January 2019 FL799A NHTSA #18V-742 Transport Canada #18-575

### Subject: Honeywell Brake Light Pressure Switches

Models Affected: Specific Freightliner Cascadia vehicles manufactured March 8, 2016, through June 30, 2017.

Fig. 1, Brake Light Pressure Switch

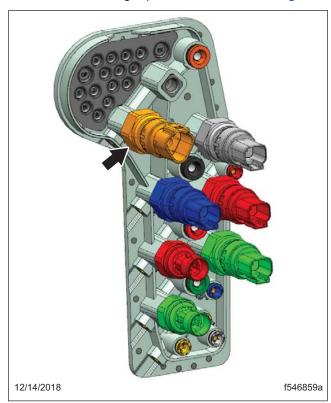
- 1. Check the base label (Form WAR259) for a completion sticker for FL799 (Form WAR260) indicating this work has been done. The base label is usually located on the front wall under the dash. If a sticker is present, no work is needed. If there is no sticker, proceed with the next step.
- 2. Park the vehicle, apply the parking brakes, and shut down the engine. Chock the tires.
- 3. Remove the lower steering column and throttle cover dash panels.
- 4. Disconnect, remove, and discard the brake light pressure switch. See Fig. 1.
